| Well Name: CORRAL BLUFF 11_14 FEDERAL COM | Well Location: T25S / R29E / SEC 2 / SWSW / | County or Parish/State: |
| Well Number: 22H | Type of Well: OIL WELL | Allottee or Tribe Name: |

Notice of Intent

Type of Action: APD Change

Wellhead diagram during offline cementing operations

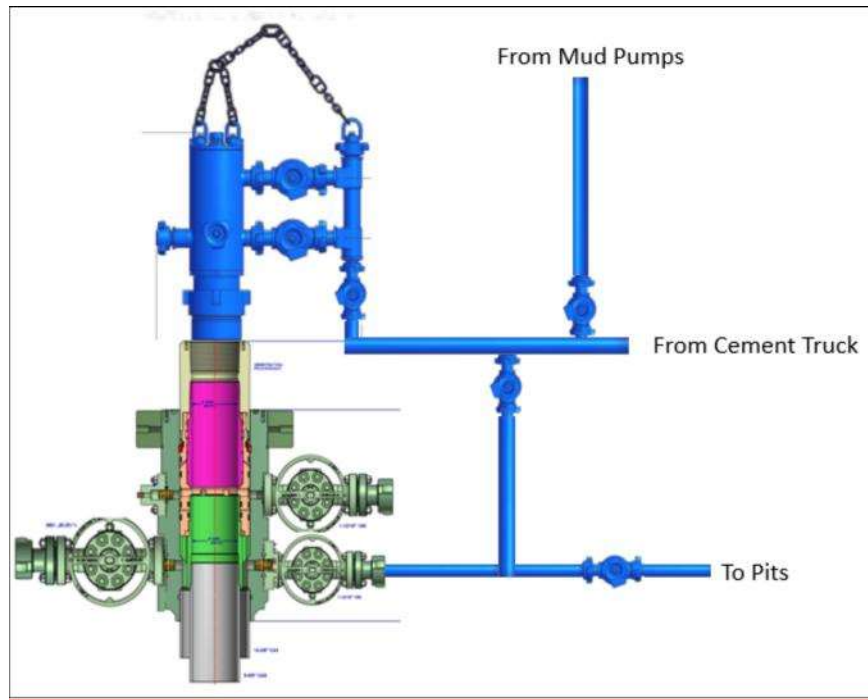
Oxy requests a variance to cement the 9.625" and/or 7.625" intermediate casing strings offline in accordance to the approved variance, EC Tran 461365.

WELL LOCATION AND ACREAGE DEDICATION PLAT

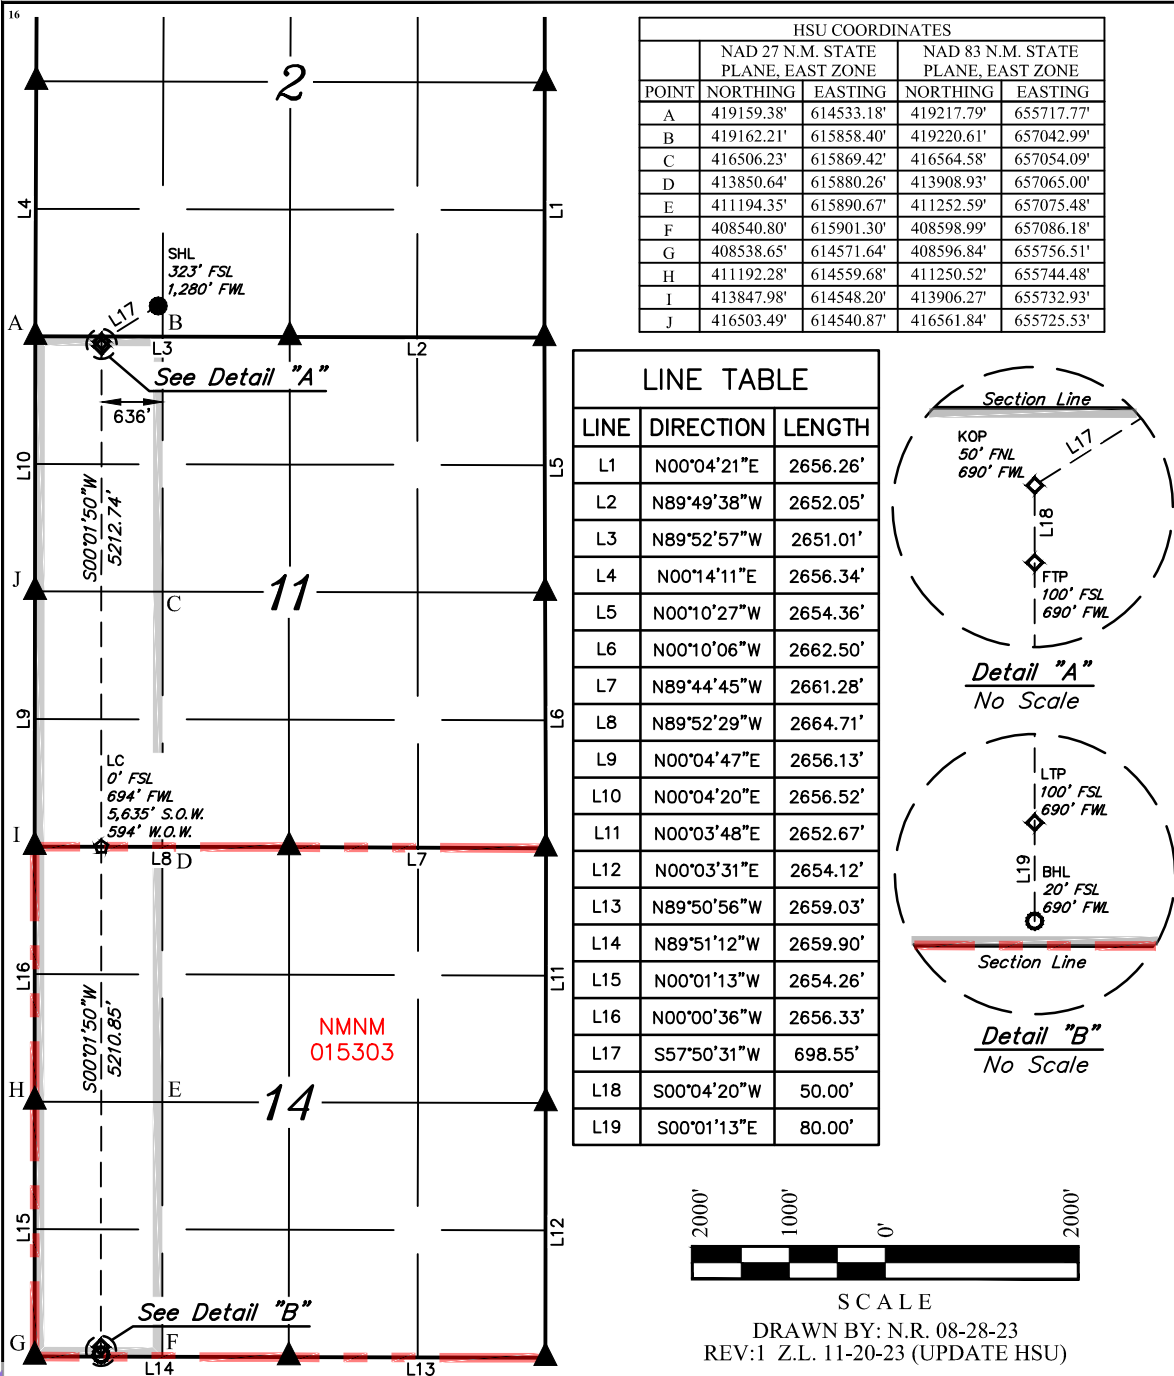
| OTHER COMMENTS |
|--|
| THE BHL, HSU SIZE, TARGET FORMATION, TVD, SURFACE CASING, INTERMEDIATE CASING, AND PRODUCTION CASING ARE CHANGING. |

| UL or lot no. M | Section 14 | Township 25S | Range 29E | Lot Idn | Feet from the 20 | North/South line SOUTH | Feet from the 690 | East/West line WEST | County EDDY |
| ¹² Dedicated Acres 320 | ¹³ Joint or Infill | ¹⁴ Consolidation Code | ¹⁵ Order No. | | | | | | |
